SERVICE INFORMATION NO. SI 42-095

Garmin G1000 System: Transponder Flight Identification Operation
ATA-Code: 34-00

NO.: 0806 Revision C

TO: All Garmin G1000 Customers
DATE: 23 October 2008
SUBJECT: G1000 Transponder Flight Identification Operation
REVISION C: Added GDU software version number

Figure 1 – PFD Timer Reference Window

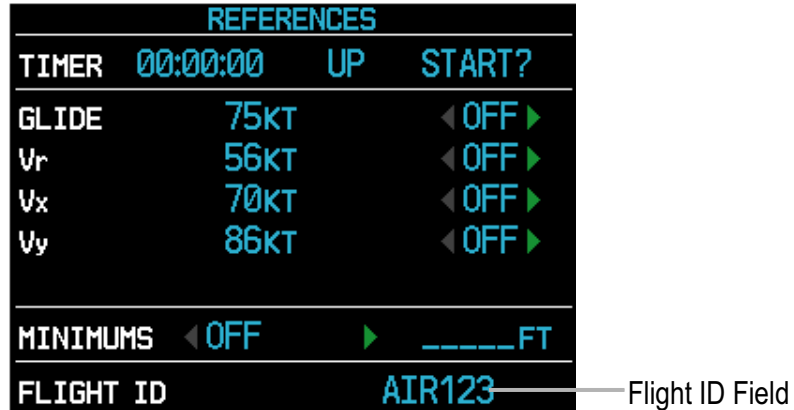
The PFD Entry configuration setting is primarily used outside the continental United States for commercial and/or training operations. Systems with PFD Entry enabled may be readily identified by the presence of a FLIGHT ID field (Figure 1) located at the bottom of the Timer/References Window on the PFD. The Flight ID differs from the 4 digit “squawk” code.

- Enter or change the Flight ID number only while the aircraft is on the ground.
- After changing a Flight ID number, do not press other keys, operate knobs on the displays, or attempt to change the Flight ID number on the other transponder (if equipped) for approximately 5 seconds until the Flight ID number update is complete as indicated by the disappearance of UPDATING in the Flight ID number field.
